Final Drainage Report

# Eagleview Subdivision El Paso County, Colorado

Prepared: December 23, 2022

Please add PCD File  
# SF-22-42

## West Tributary – Existing Conditions

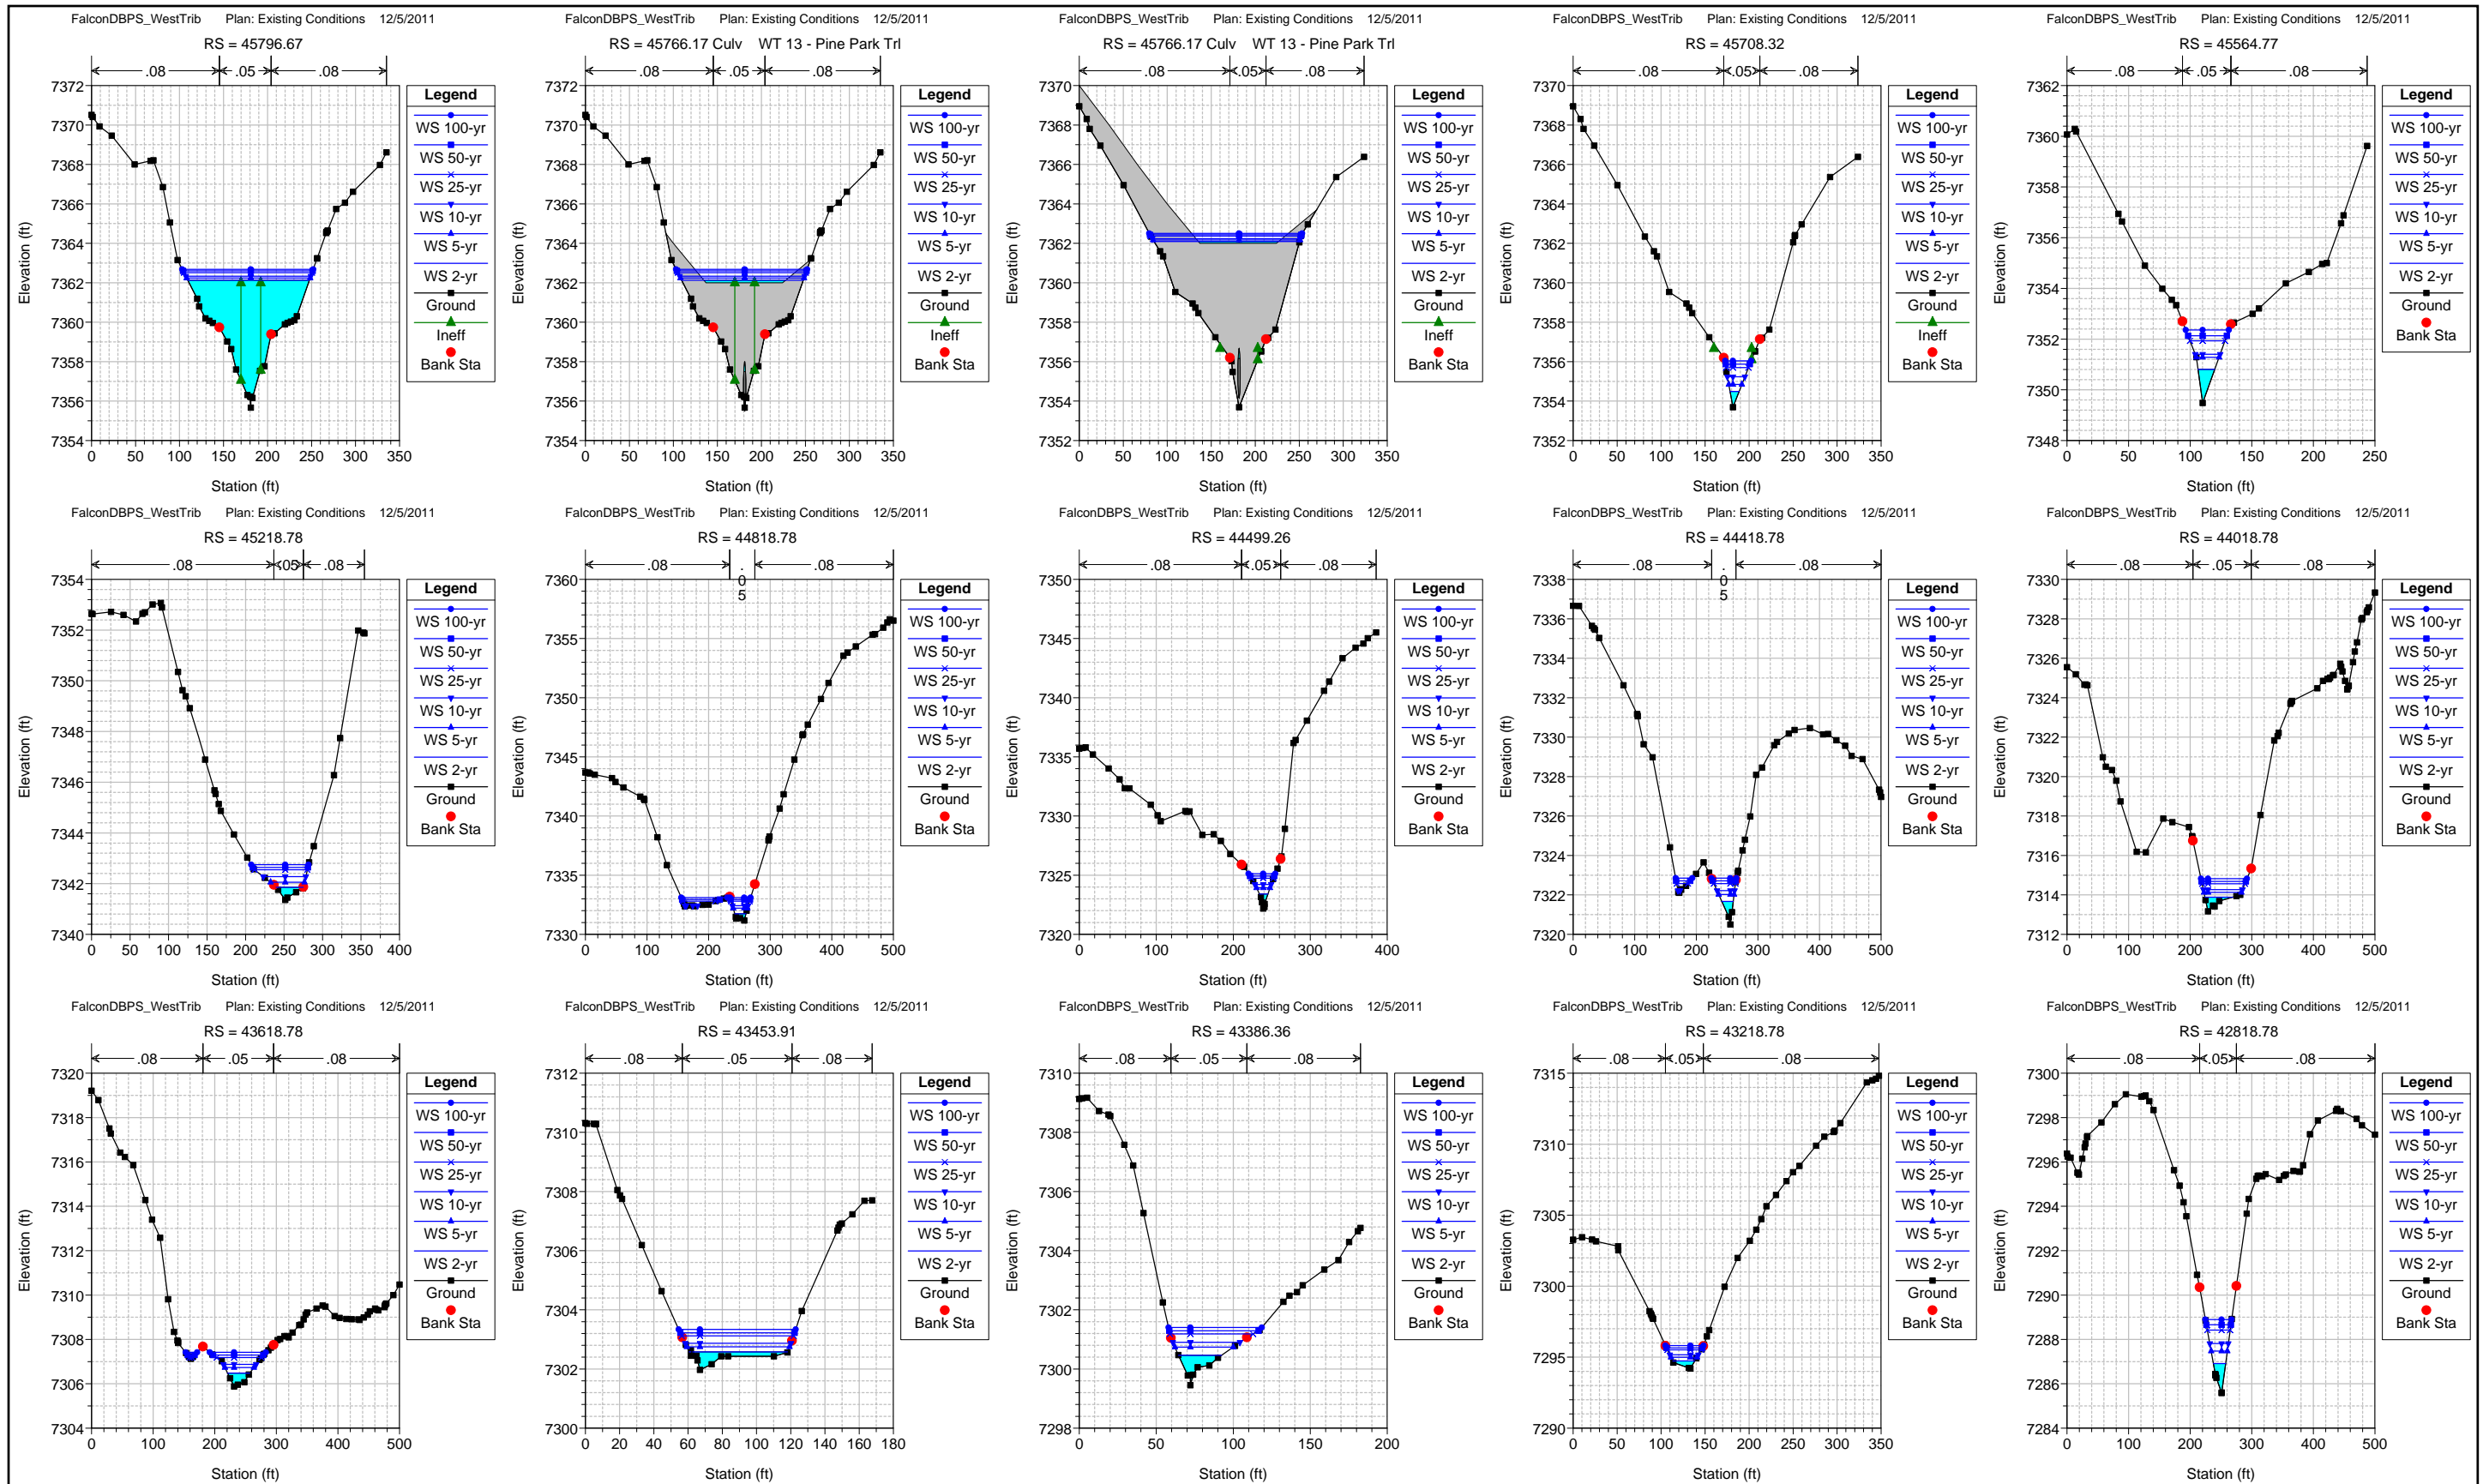
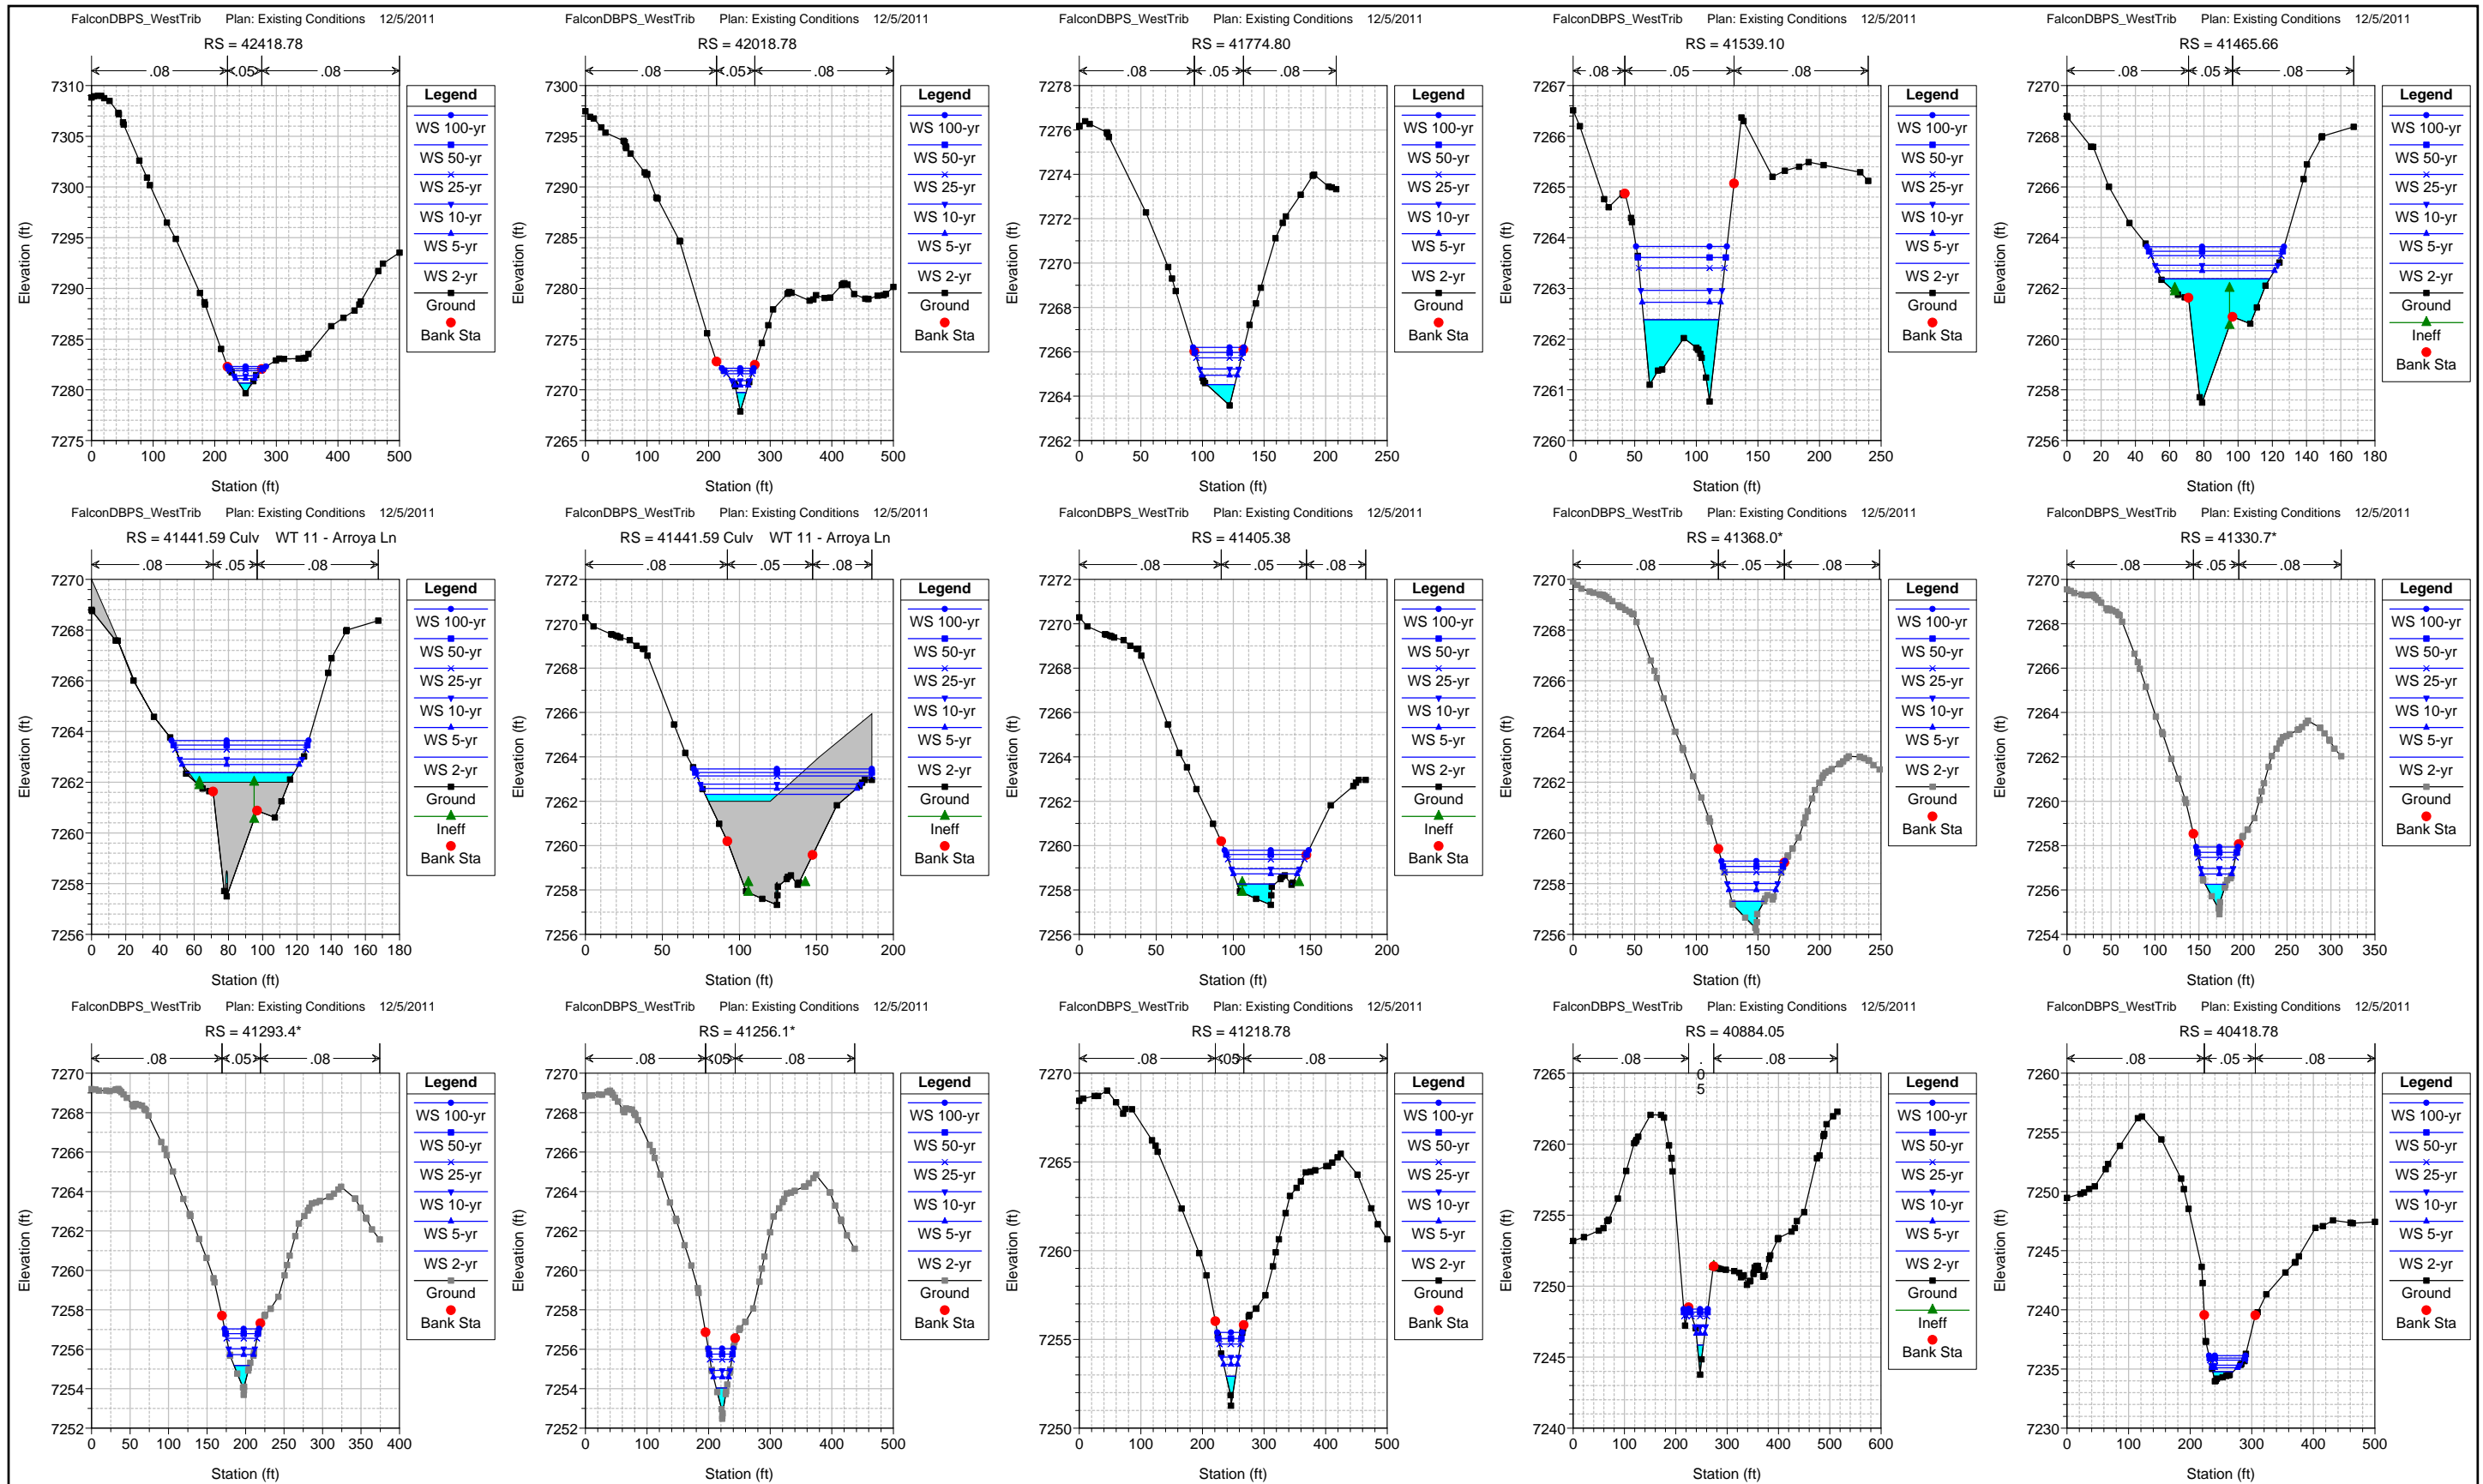
Provide an existing and proposed HEC-RAS Map showing the cross section cuts.

Contact the review engineer to discuss. Is the HEC-RAS included from the DBPS? Is there going to be a separate modeling specific to the proposed improvements?

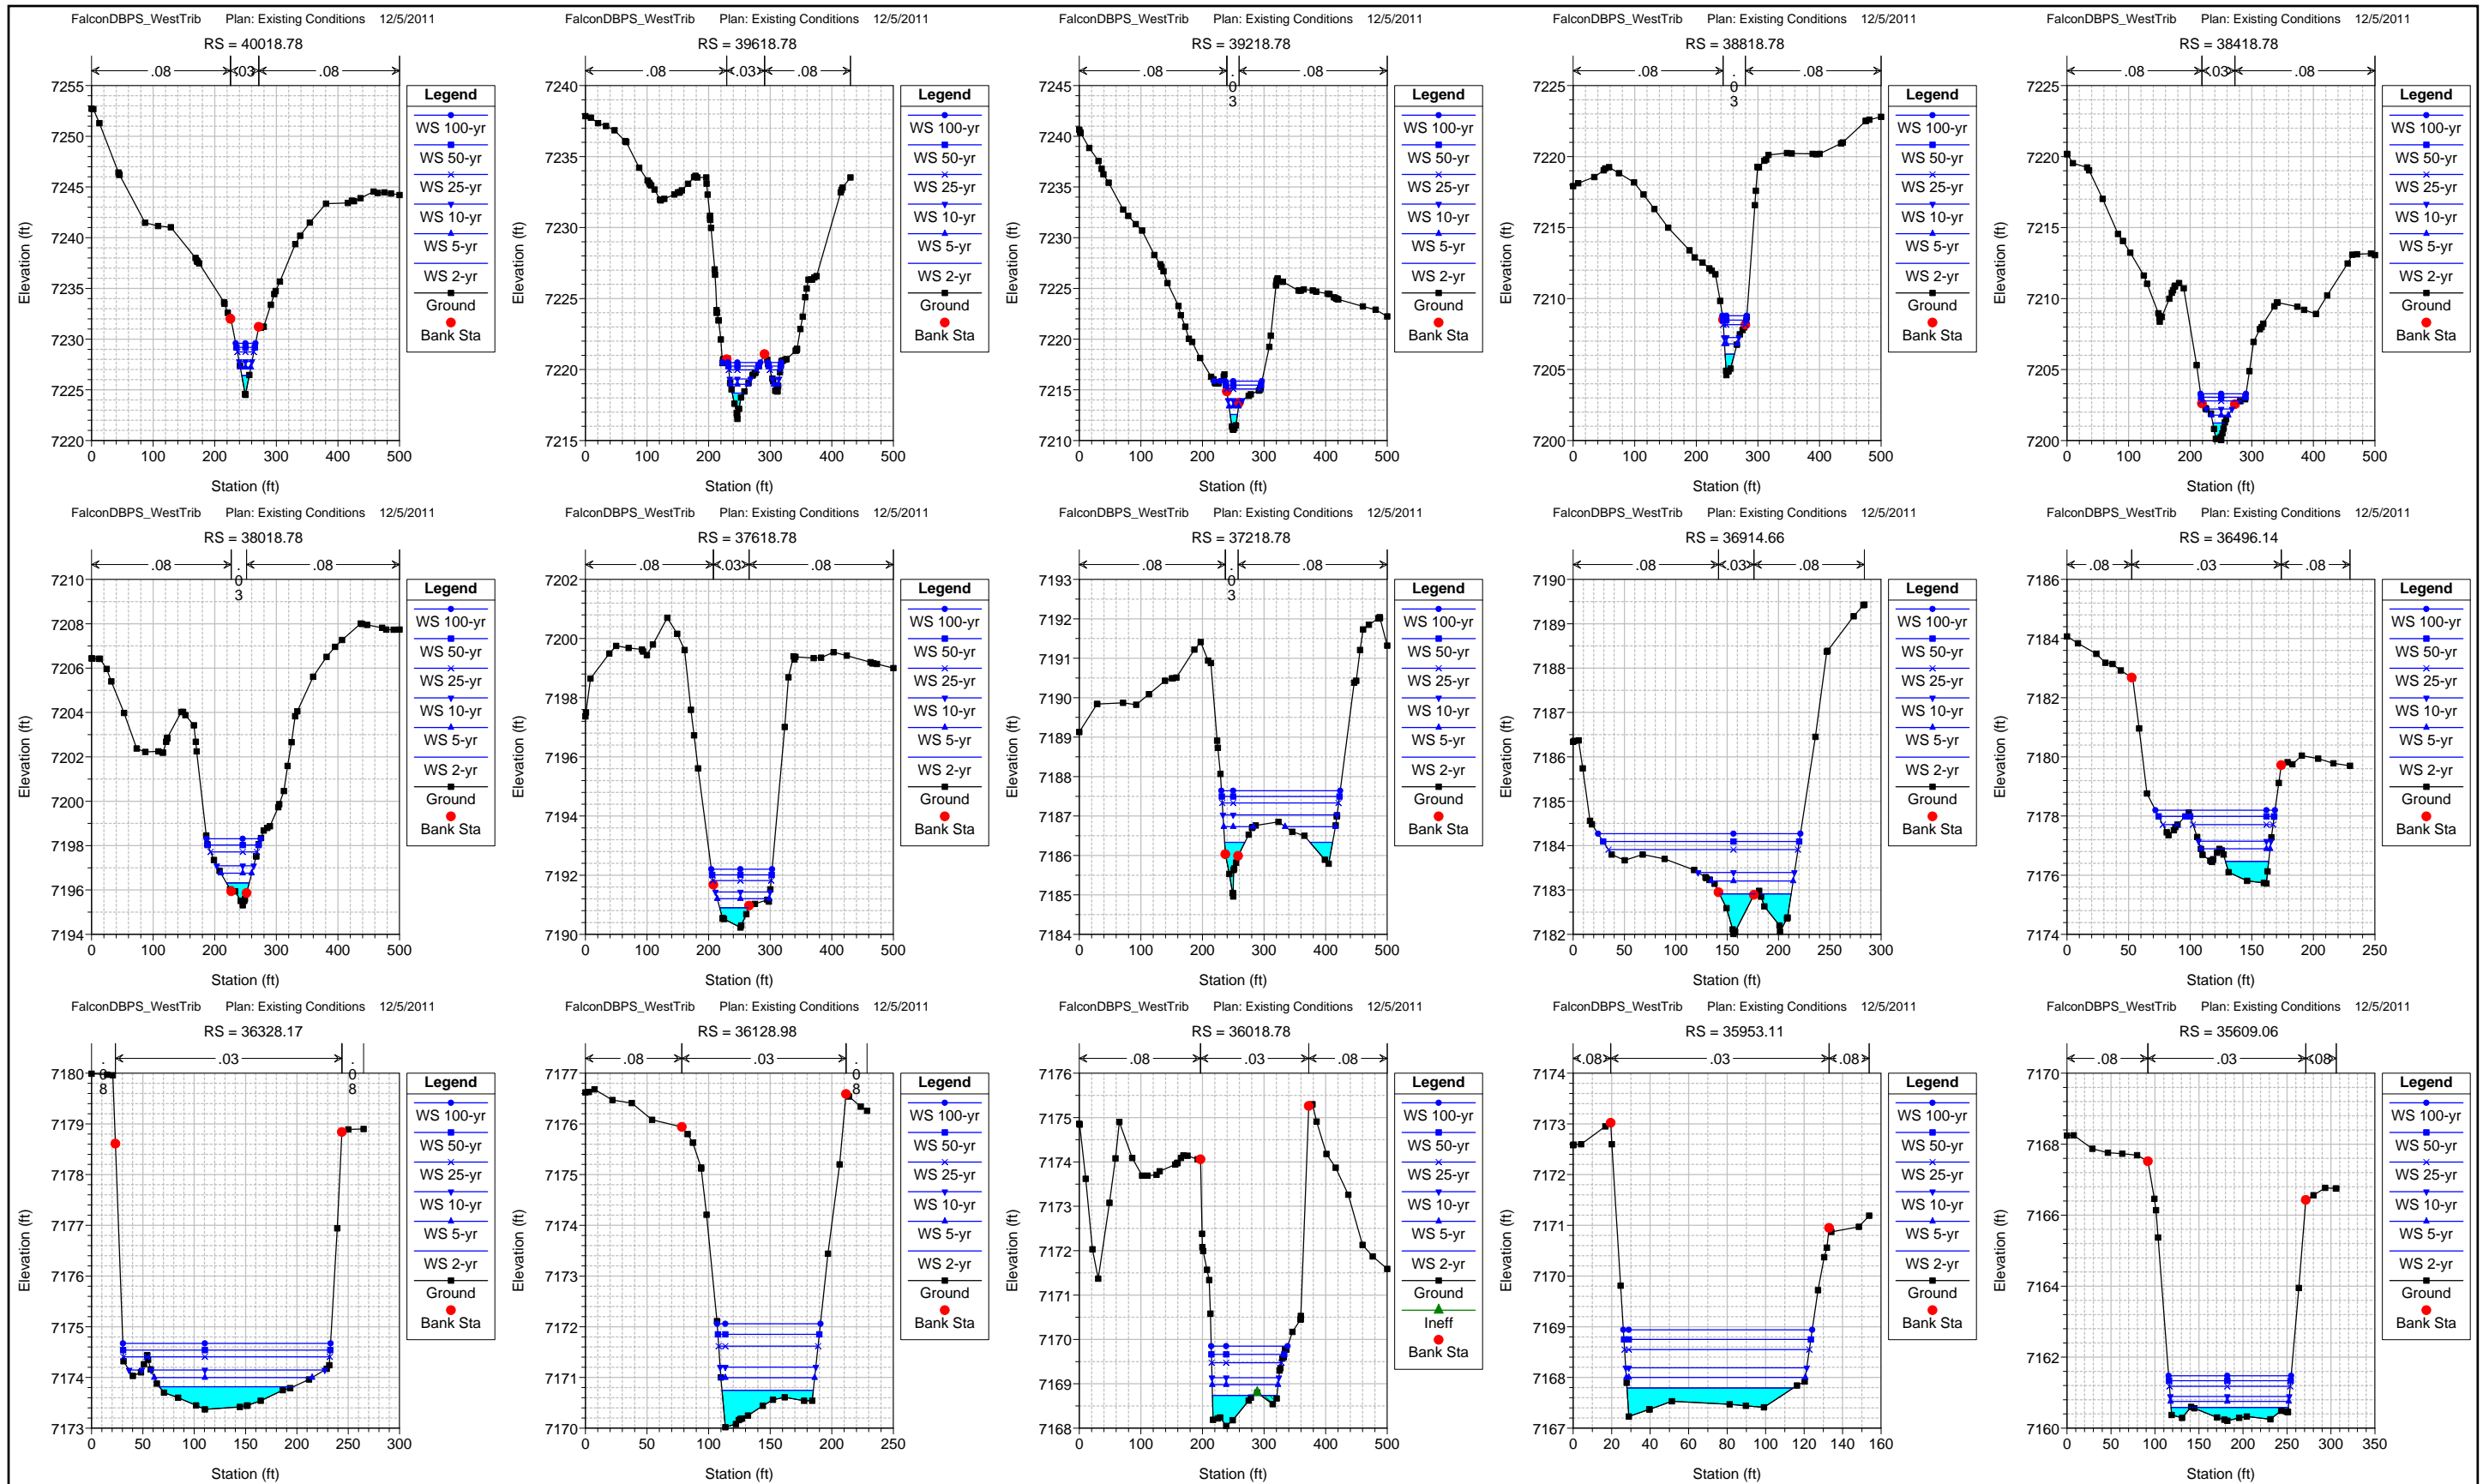
Not clear why this is included in the report. It seems this can be removed.
